Access Compliance Report

Public Rights-of-Way

Intersection ID: 47834	Main Street: ALVARADO_WY	Cross Street: CAMP_VERDE_LN	Location: E
ADA ID: 79B7C667F6AC	Ramp Type: PerpDiag	Initial Pass/Fail: Fail	Overall Compliance: No
		Severity Score: 8.75

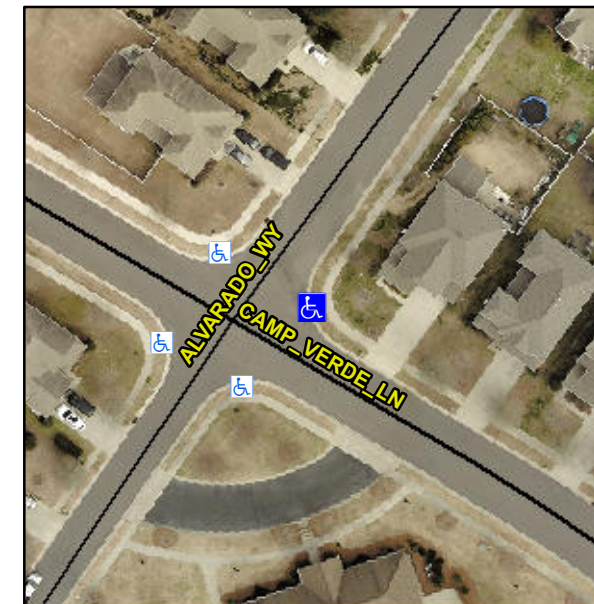
R304.5.1

Compliance	Description	Data	Compliance	Description	Data
N/A	Ramp Length (in)	132.0	Yes	Ramp Slope (%)	6.3
No	Ramp Width (in)	46.0	Yes	Ramp XSlope (%)	0.9
N/A	Flare Type LT	N/A	N/A	Flare Type RT	N/A
N/A	Flare Slope LT (%)	N/A	N/A	Flare Slope RT (%)	N/A
N/A	Flare Traversable LT?	N/A	N/A	Flare Traversable RT?	N/A
N/A	Landing Length (in)	N/A	N/A	DWS Provided?	N/A
N/A	Landing Width (in)	N/A	N/A	DWS Contrast?	N/A
N/A	Landing Slope (%)	N/A	N/A	DWS Length (in)	N/A
N/A	Landing X Slope (%)	N/A	N/A	DWS Full Width?	N/A
N/A	Landing Curb? (Y/N)	N/A	N/A	DWS Offset (in)	N/A
N/A	Shared Landing?	N/A			
N/A	Gutter Ponding?	N/A	N/A	Gutter Slope (%)	N/A
N/A	Gutter Lip Ht (in)	N/A	N/A	Gutter X Slope (%)	N/A
N/A	Painted X Walk1?	No	N/A	Painted X Walk2?	No
	X Walk 1 Direction	To NW		X Walk 2 Direction	To SW
N/A	X Walk 1 Width (in)	N/A	N/A	X Walk 2 Width (in)	N/A
	X Walk 1 Slope (%)	1.0		X Walk 2 Slope (%)	0.9
	X Walk 1 X Slope (%)	0.2		X Walk 2 X Slope (%)	0.3

Remove & Replace Curb Ramp With Two New Directional Ramps or Equivalent.
